July 3, 2017  
File: 21081375

Reference: **Peer Review – Stormwater Management and Erosion Control  
Belmont Day School Barn and Entry Drive  
Belmont, Massachusetts**

On behalf of the Belmont Day School, we submit this letter with response to the to the comments contained in the letter prepared by BSC Group to your office dated June 28, 2017. Original comments issued by the BSC Group are shown in italic and responses from Stantec are noted below each comment.

**L0.01**

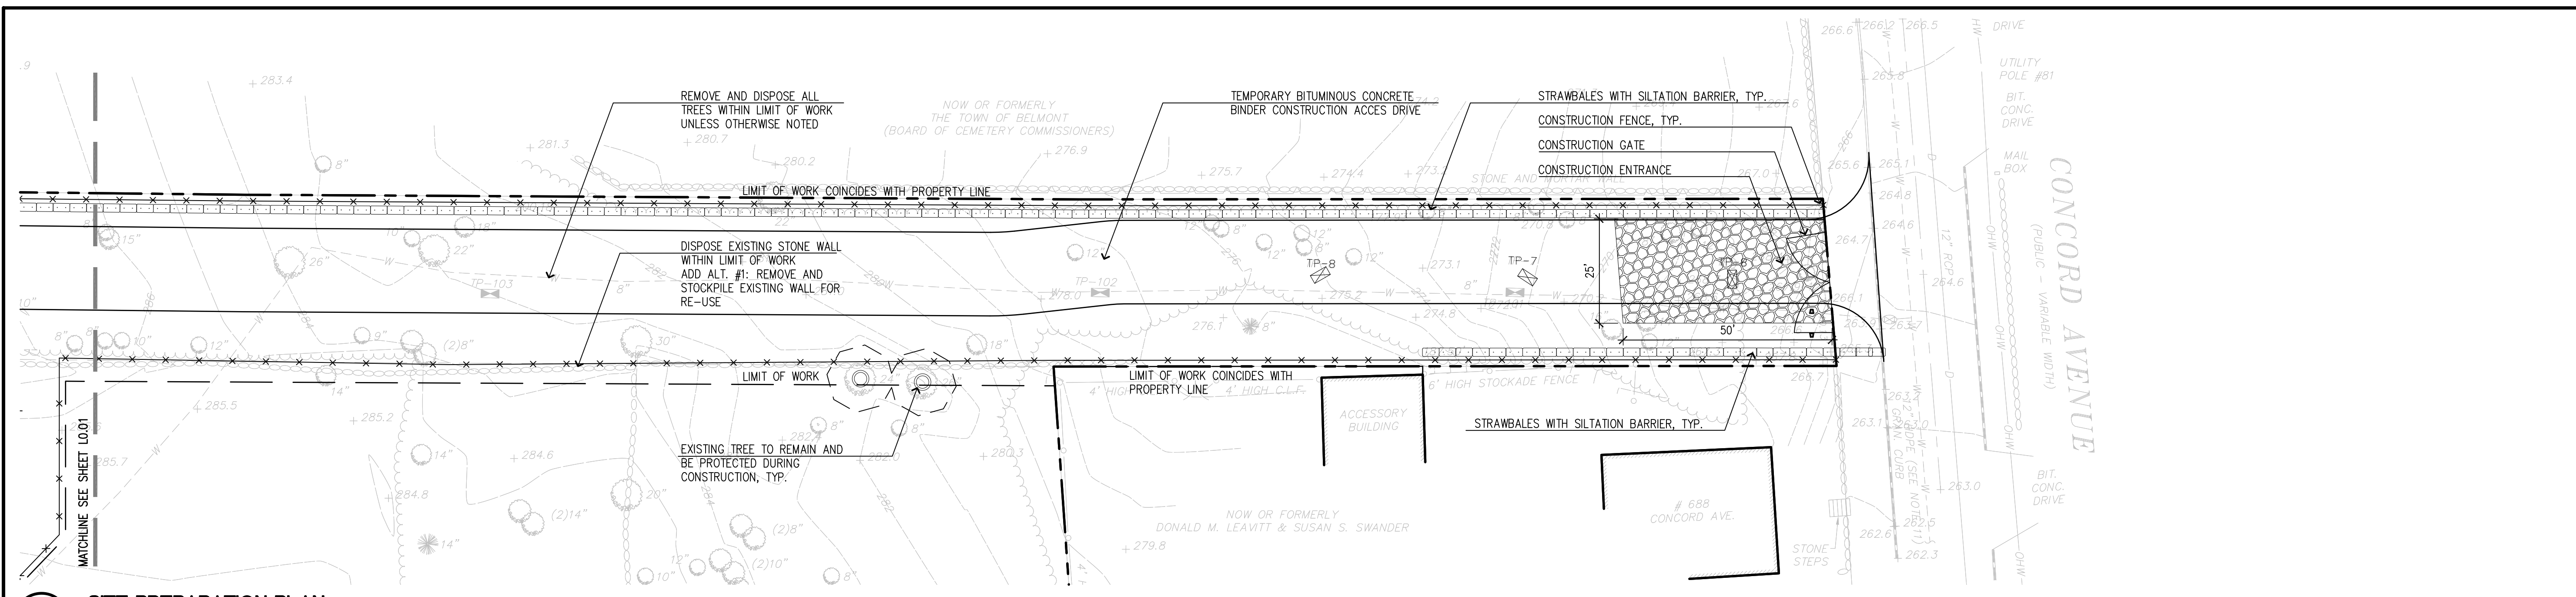
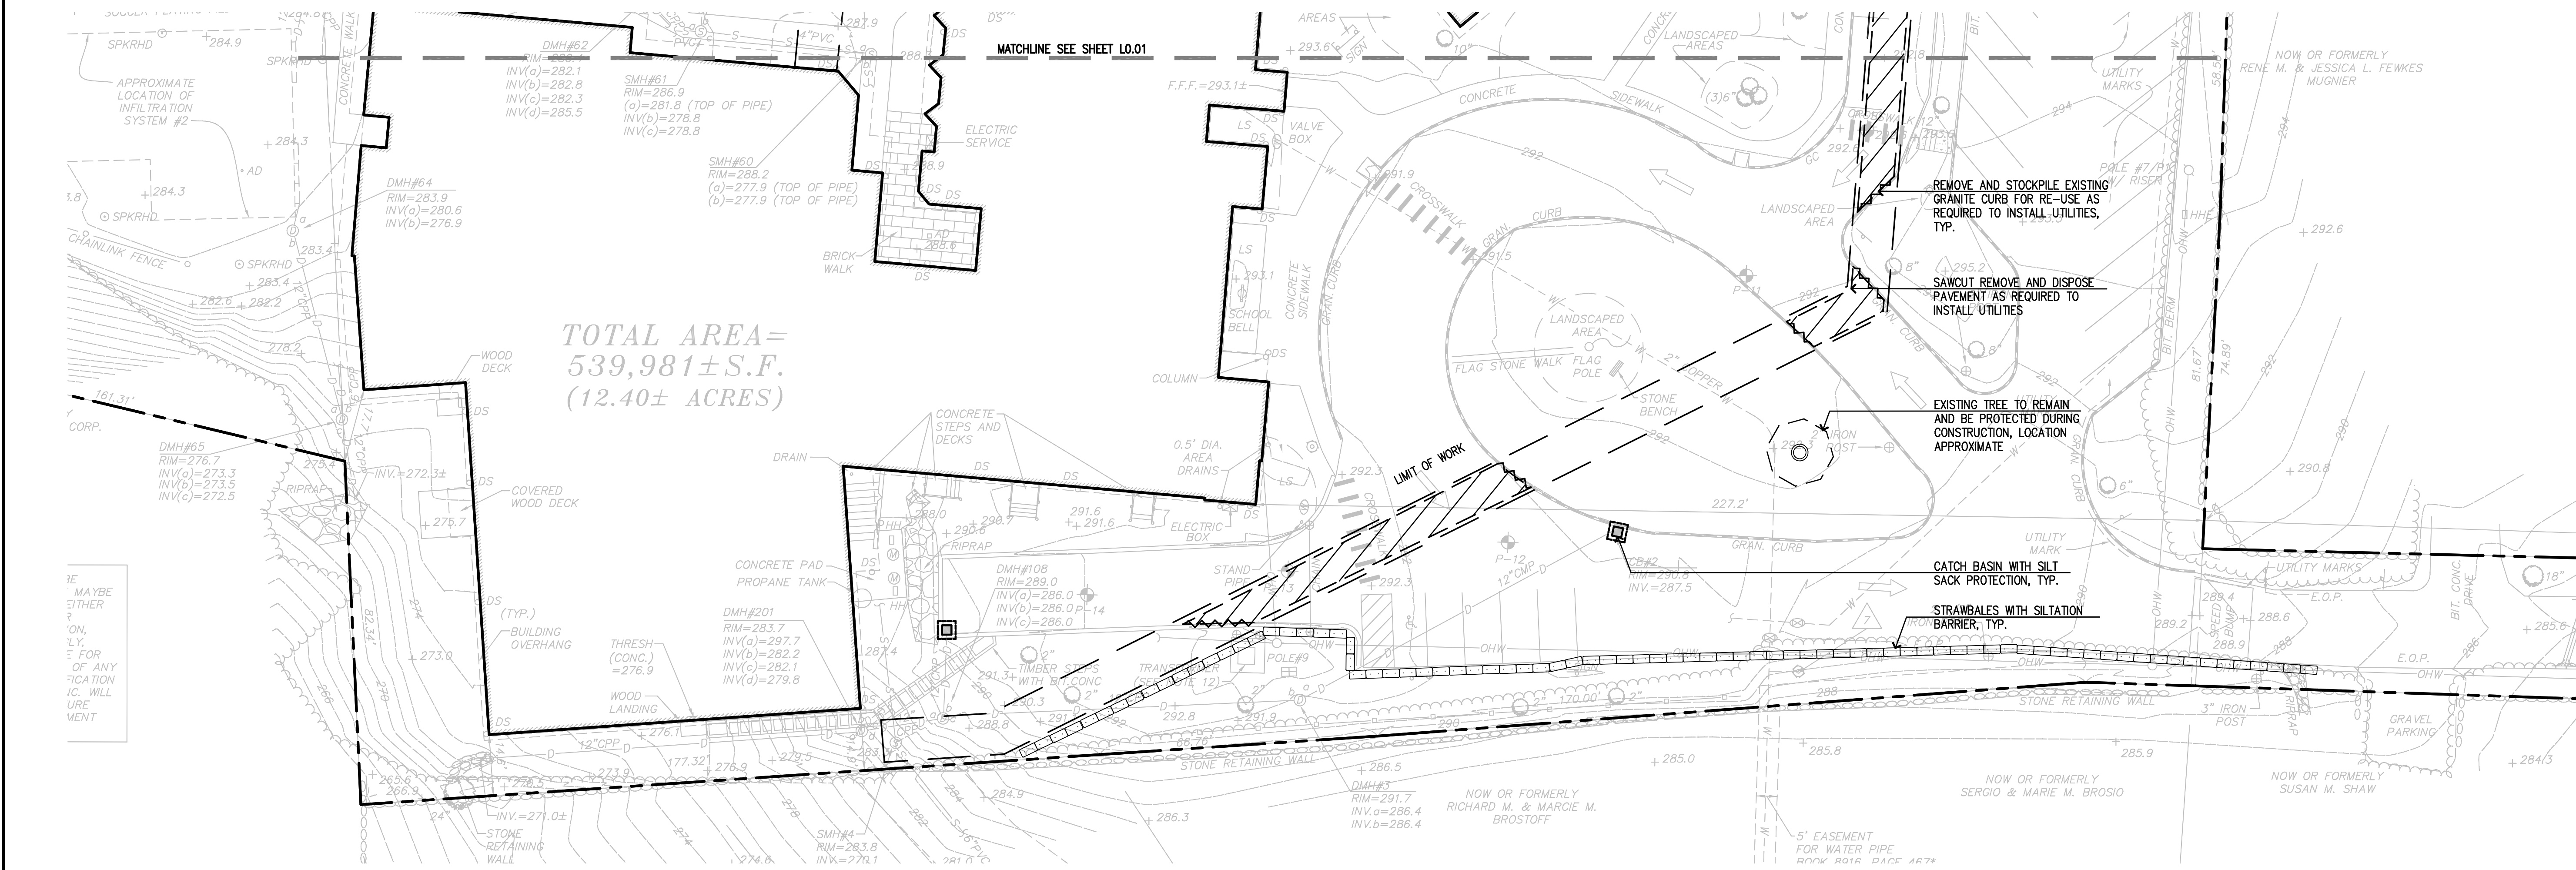
4. **Comment:** *While appropriate erosion and sedimentation controls are shown on the project plans, we recommend that the symbol used for catch basin silt sack protection be revised to stand out more. The current symbol used blends into the background and is easily missed.*

5. **Comment:** *We recommend that the site preparation plan include notes requiring the contractor to maintain and remove all temporary controls during and at the conclusion of construction and that all strawbales used are guaranteed free of weed and invasive seeds.*

**Response:** Acknowledged. The symbol on the Site Preparation Plans (Drawings L0.01 and L0.02) have been revised and the revised plans are attached.

**Response:** Acknowledged. We have added the suggested note to the Site Preparation Plan (Drawing L0.01), and the revised plan is attached.

**L1.02**

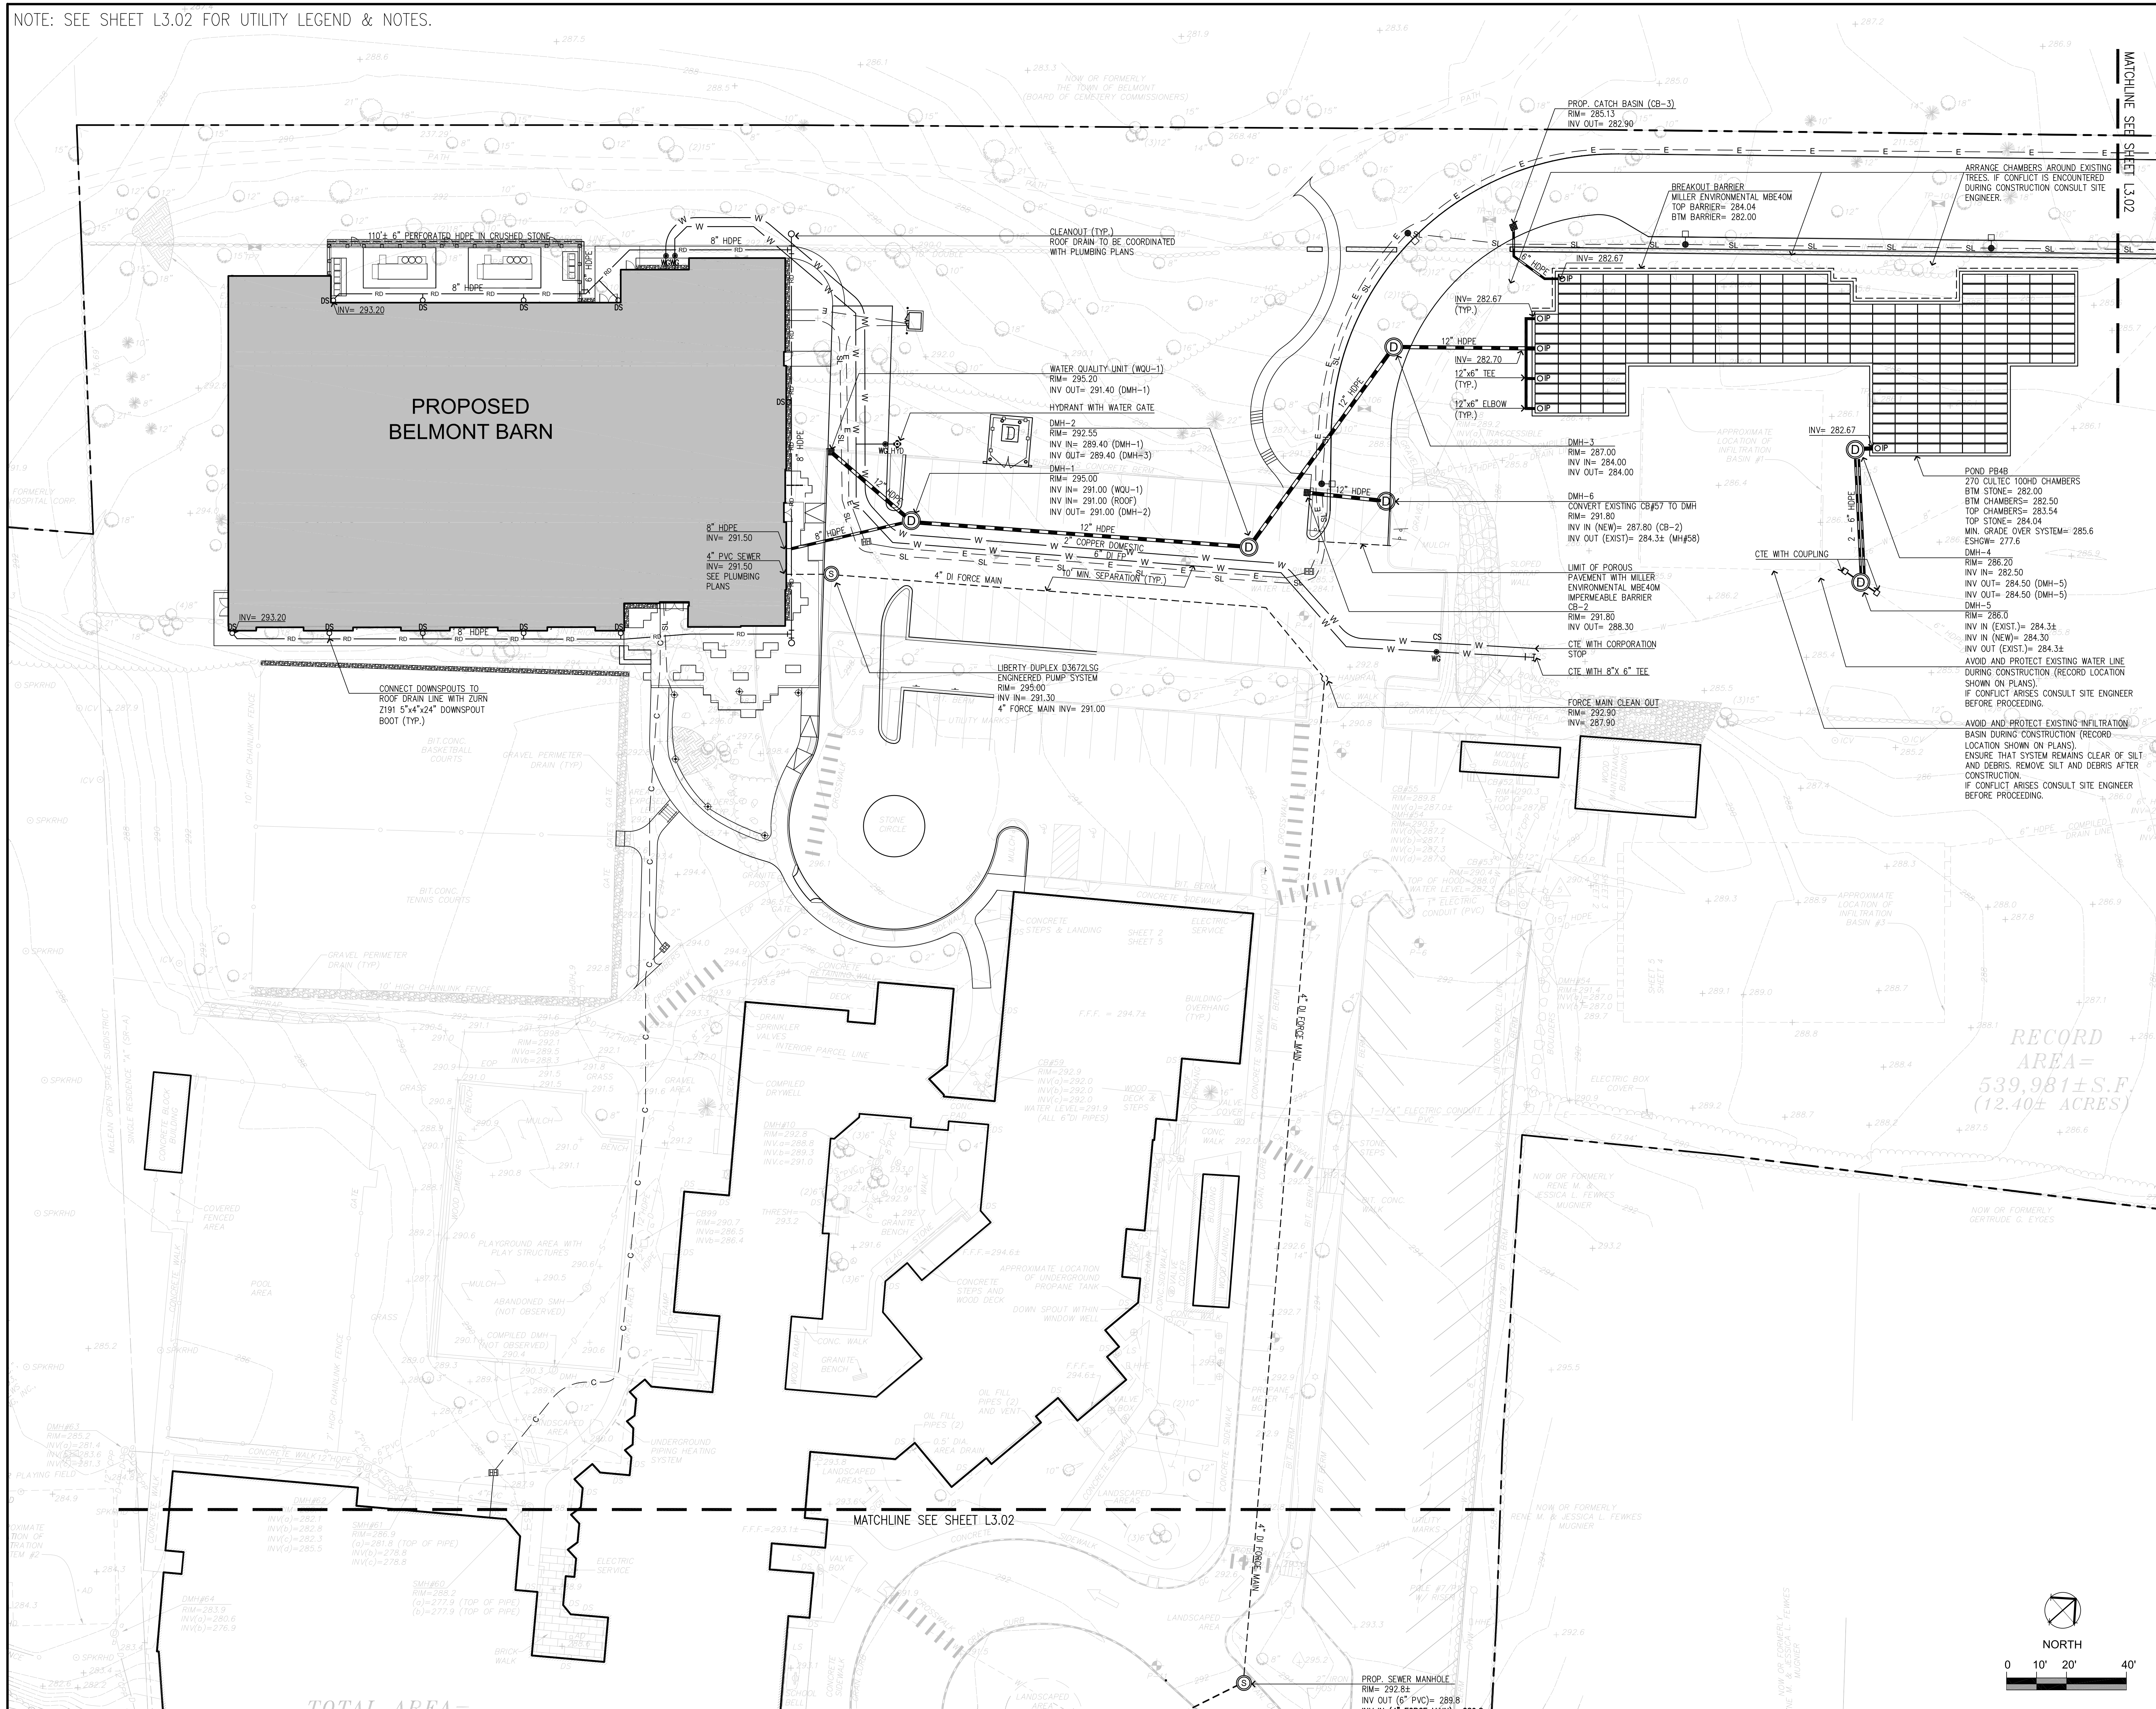
12. **Comment:** *We recommend that signs be installed identifying the limits of the porous asphalt. These signs should include prohibitions against the use of sand and of snow storage on the porous asphalt.*

**Response:** Acknowledged. We have added a sign the Layout and Materials Plan (Drawing L1.02), to be located near the beginning of the driveway that will note that sand should not be used and that no storage on the porous pavement is allowed.
